ADDENDUM NO. 2

**Coventry Township
NEW FIELD HOUSE
Logan Field
2701 North turkeyfoot Road
Akron, Ohio 44319**

**Prepared by
Four Points Architectural Services, Inc.**

April 29, 2024

1 SOUTH ELEVATION
 A4.2 1/4" = 1'-0"

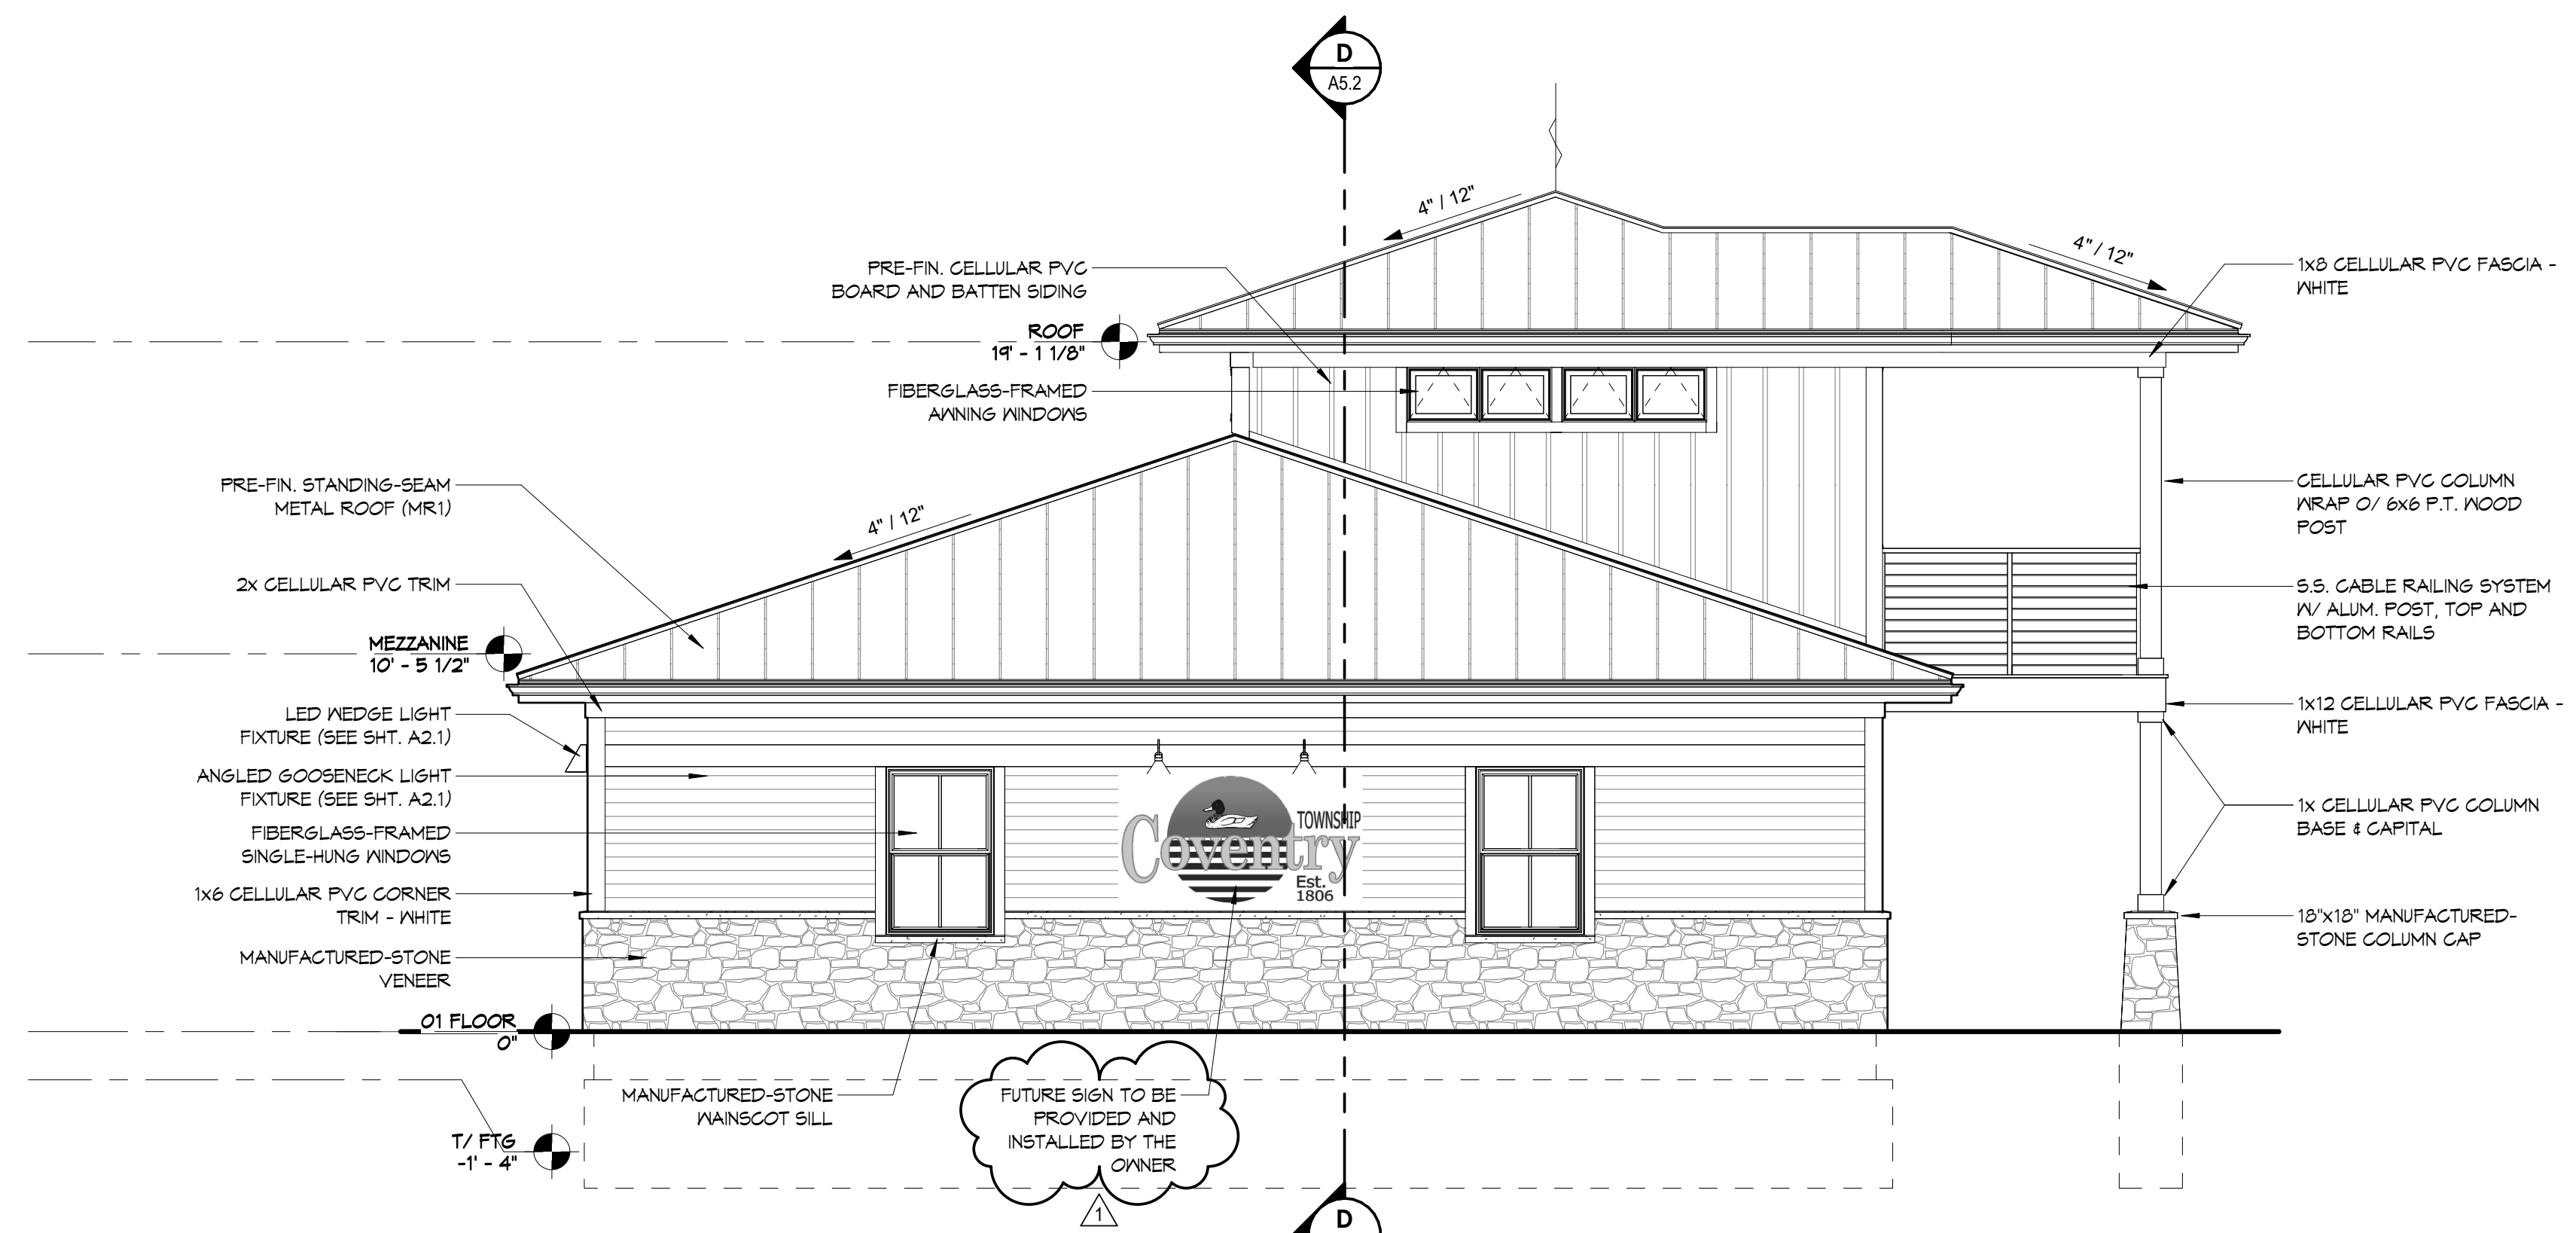
4. **Sheet A4.2 – South & West Exterior Elevations:**

- a. The height of Door 101A has been revised to be 7'-4". This change also affects the trim layout around the door.
- b. The note for the sign to be mounted on the west wall has been revised: "Future sign to be provided and installed by the Owner."

BUILDING SECTIONS

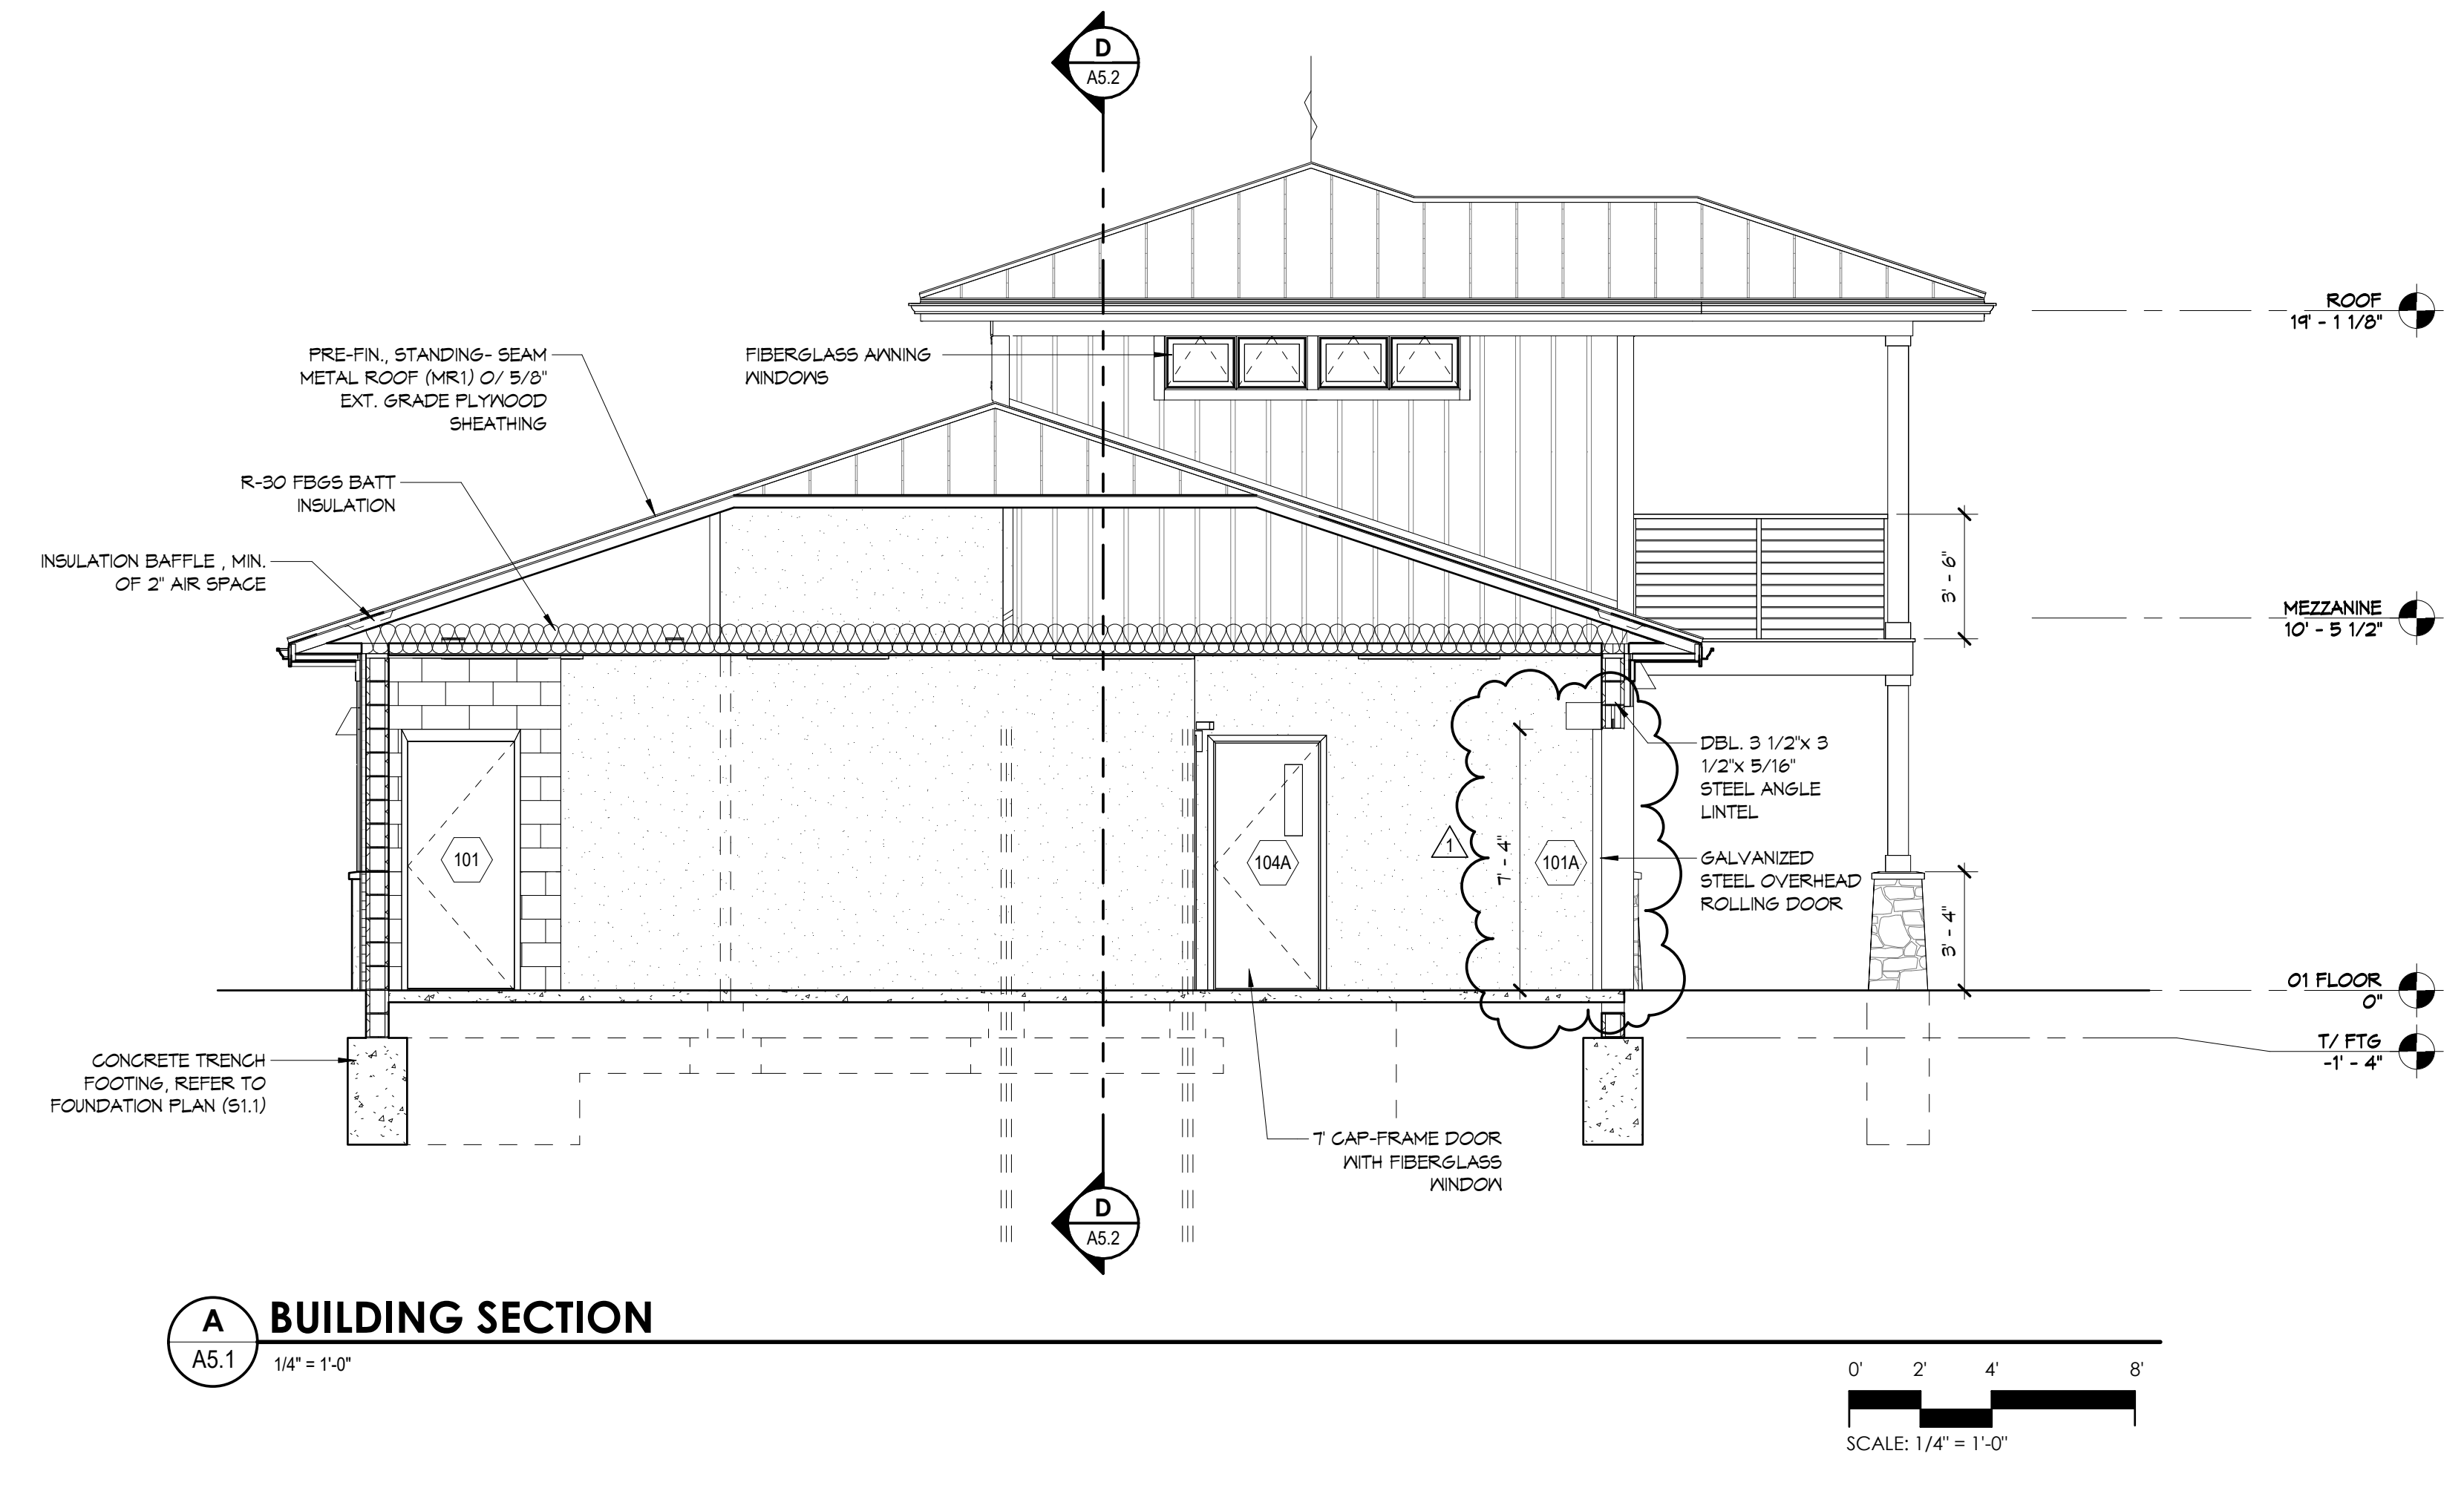
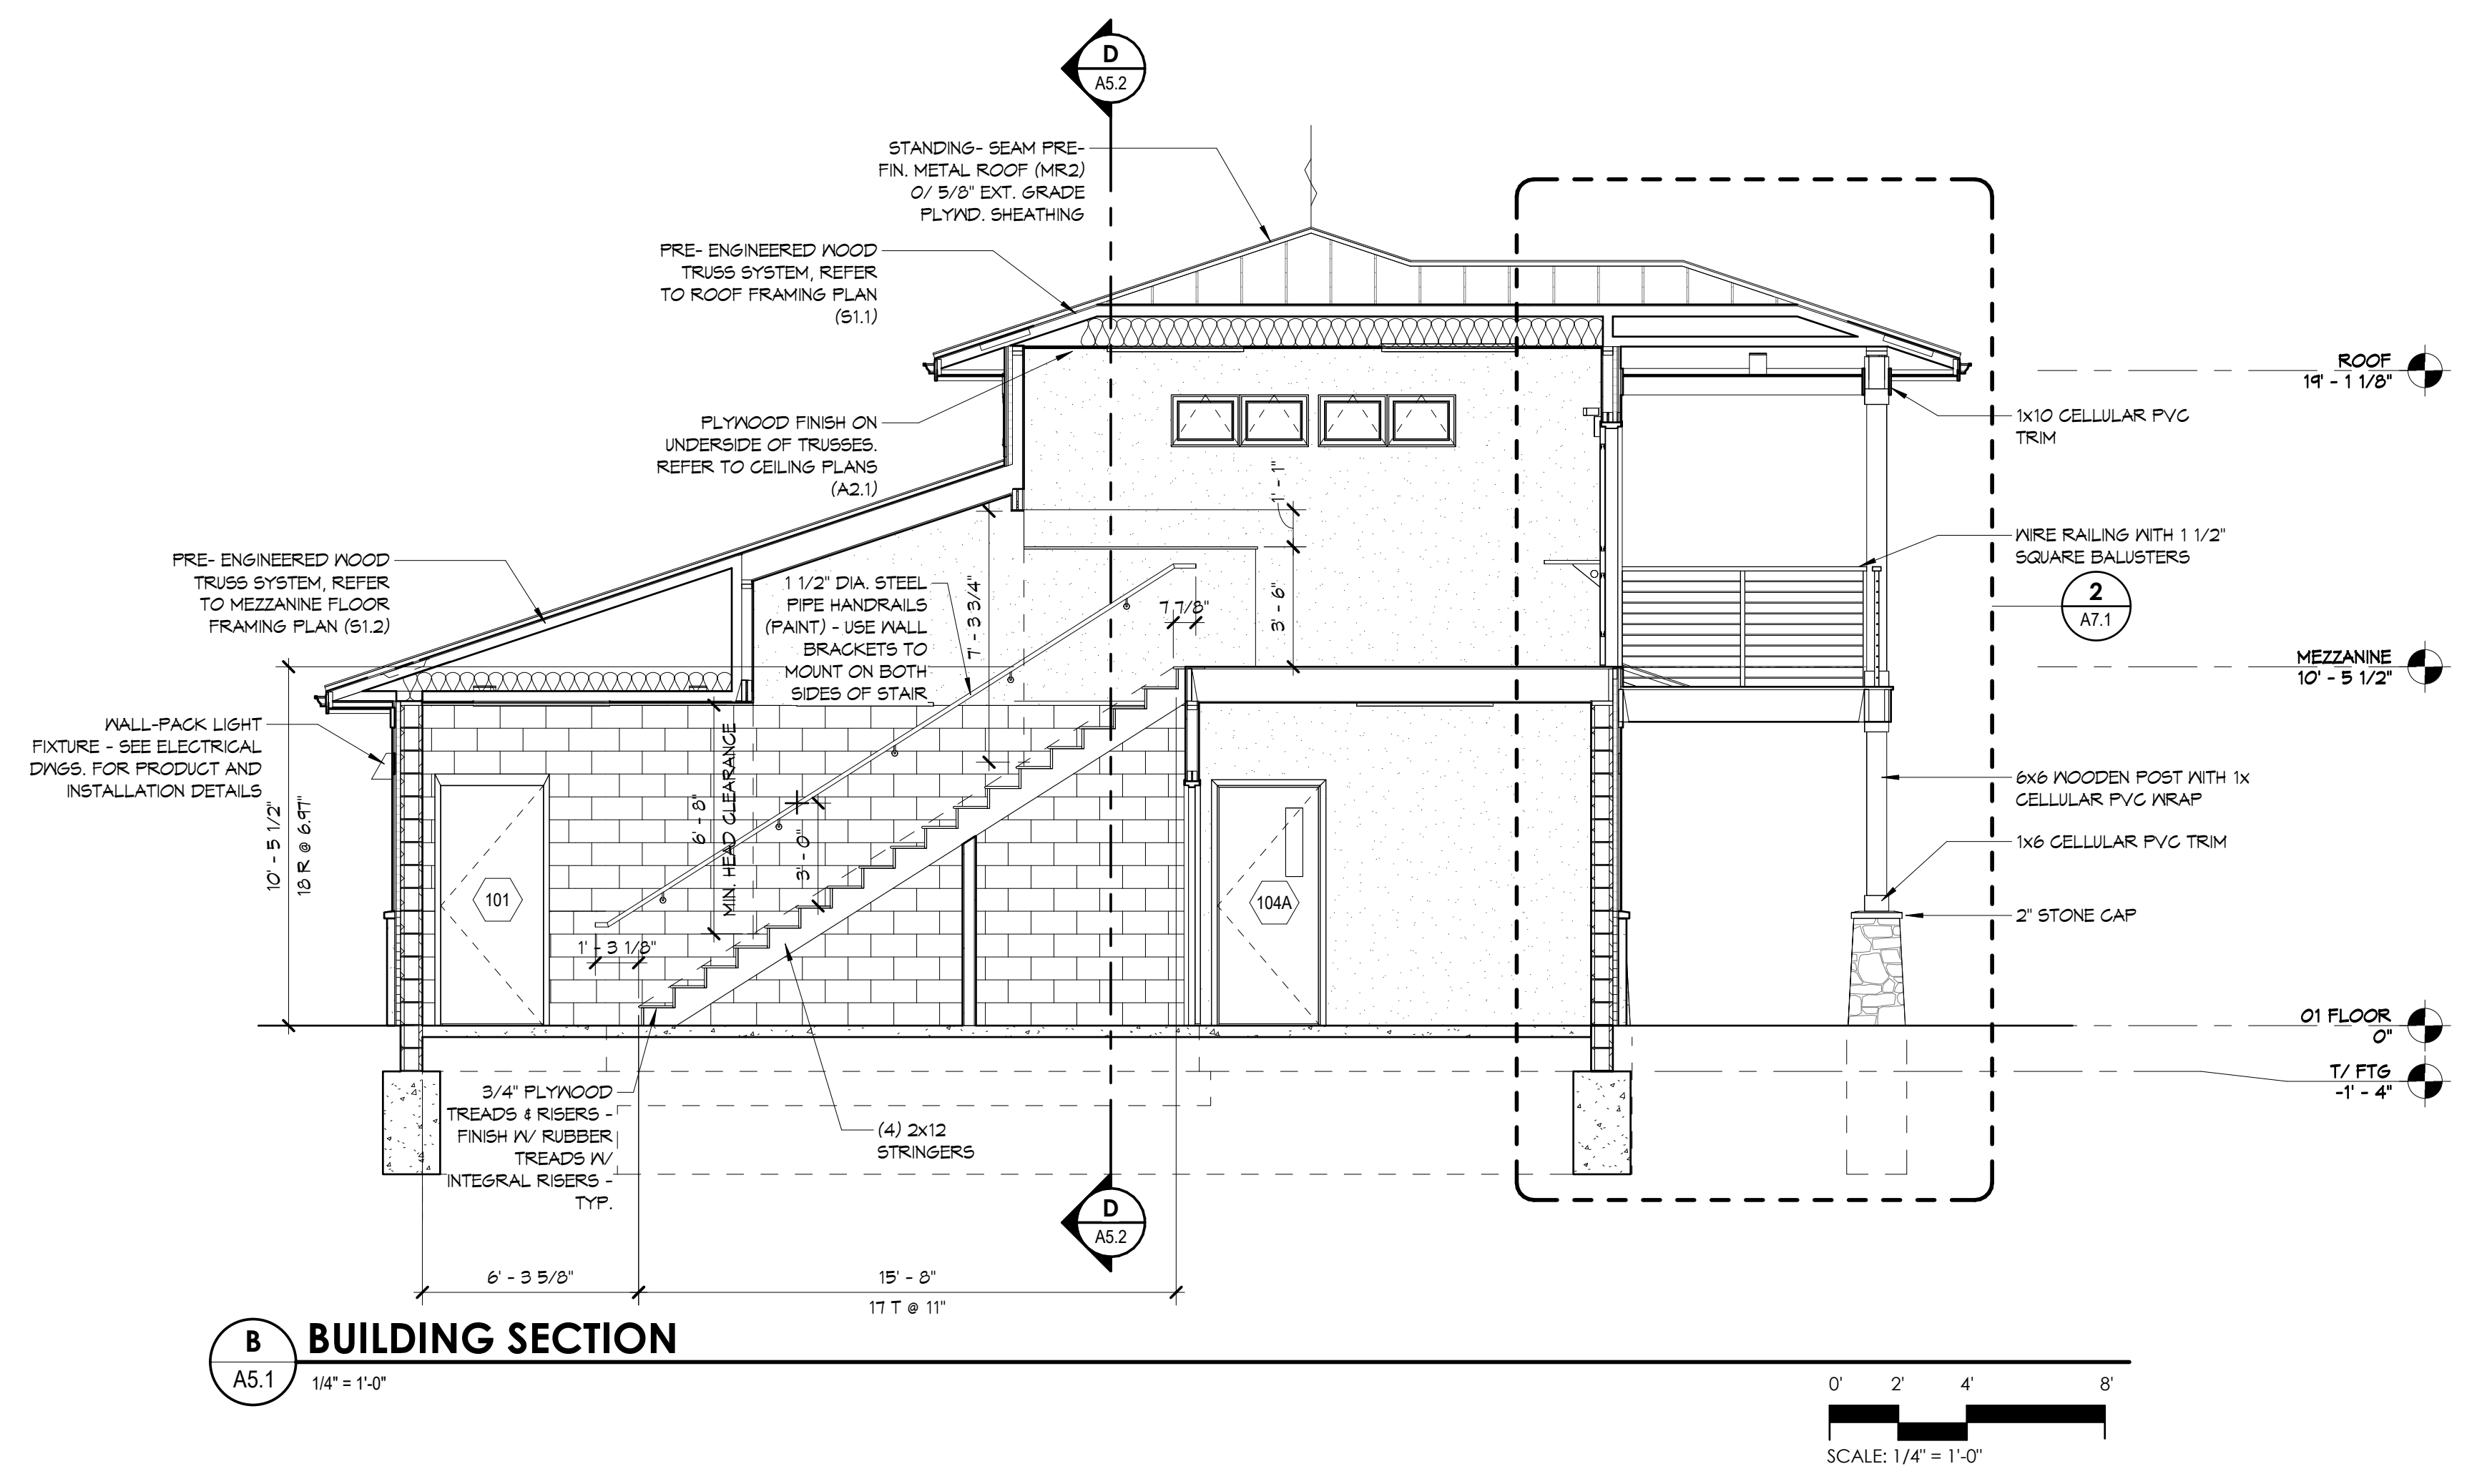
5. **Sheet A5.1 – Building Sections:**

- a. Building Section A/A5.1 – The height of Door 101A has been revised.
